# Access Compliance Report

## Public Rights-of-Way

### (Curb Ramps)

Intersection ID: 30005	Main Street: BACKWATER_DR	Cross Street: BRIGHTHAVEN_LN	Location: SW
ADA ID: 5F2779247F1E	Ramp Type: PerpDiag	Initial Pass/Fail: Fail	Overall Compliance: No
		Severity Score: 1.25

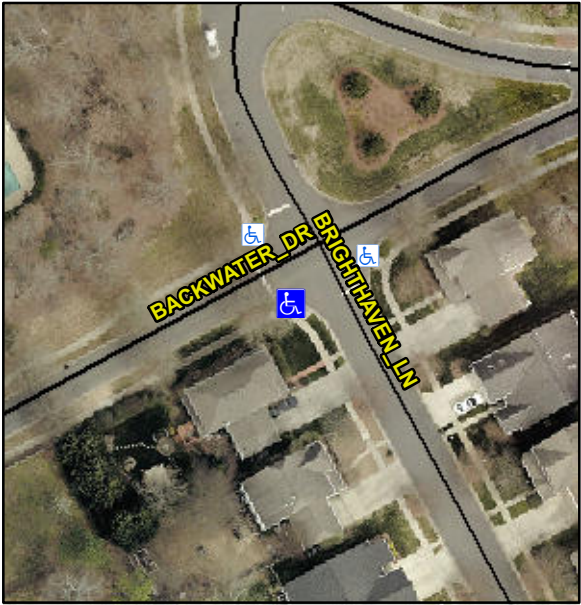
Codes/Mitigation Info/Possible Solution			Field Measurements/Component Compliance		
	Possible Solutions:		<b>Compliance</b>	<b>Description</b>	<b>Data</b>
	<b>Remove &amp; Replace Curb Ramp With Two New Directional Ramps or Equivalent.</b>		<b>Yes</b>	Ramp Length (in)	<b>59.0</b>
			<b>N/A</b>	Ramp Width (in)	<b>48.0</b>
			<b>N/A</b>	Flare Type LT	<b>N/A</b>
			<b>N/A</b>	Flare Slope LT (%)	<b>N/A</b>
			<b>N/A</b>	Flare Traversable LT?	<b>N/A</b>
			<b>N/A</b>	Landing Length (in)	<b>N/A</b>
			<b>N/A</b>	Landing Width (in)	<b>N/A</b>
			<b>N/A</b>	Landing Slope (%)	<b>N/A</b>
			<b>N/A</b>	Landing X Slope (%)	<b>N/A</b>
<p>Surveyor Notes:</p> <p><b>N/A</b></p> <p>PROW/ADA:</p> <p><b>R304.5.3</b></p>			<b>N/A</b>	Flare Type RT	<b>N/A</b>
			<b>N/A</b>	Flare Slope RT (%)	<b>N/A</b>
			<b>N/A</b>	Flare Traversable RT?	<b>N/A</b>
			<b>N/A</b>	DWS Provided?	<b>N/A</b>
			<b>N/A</b>	DWS Contrast?	<b>N/A</b>

<b>N/A</b>	DWS Length (in)	<b>N/A</b>
			<b>N/A</b>	DWS Full Width?	<b>N/A</b>
			<b>N/A</b>	DWS Offset (in)	<b>N/A</b>
			<b>N/A</b>	Gutter Ponding?	<b>N/A</b>
			<b>N/A</b>	Gutter Lip Ht (in)	<b>N/A</b>
			<b>No</b>	Painted X Walk1?	<b>No</b>
			<b>To E</b>	X Walk 1 Direction	<b>To N</b>
			<b>N/A</b>	X Walk 1 Width (in)	<b>N/A</b>
			<b>5.6</b>	X Walk 1 Slope (%)	<b>4.7</b>
			<b>1.4</b>	X Walk 1 X Slope (%)	<b>5.0</b>
			<b>N/A</b>	Ramp inside XWalk1?	<b>N/A</b>
			<b>1.7</b>	Road Slope (%)	<b>N/A</b>
			<b>5.5</b>	Road X Slope (%)	<b>N/A</b>
			<b>N/A</b>	Any Obstructions?	<b>N/A</b>
			<b>N/A</b>	Obstruction Type	<b>N/A</b>
Total Cost:			<b>\$ 3200.00</b>		
			<b>N/A</b>	Clear Space?	<b>N/A</b>
			<b>N/A</b>	Clear Space to XWalk (in)	<b>N/A</b>
			<b>N/A</b>	Storm Grate/Utility Hazard?	<b>N/A</b>
			<b>N/A</b>	Storm Grate/Utility Type	<b>N/A</b>
			<b>Yes</b>	Surface Condition? (G/P)	<b>Good</b>
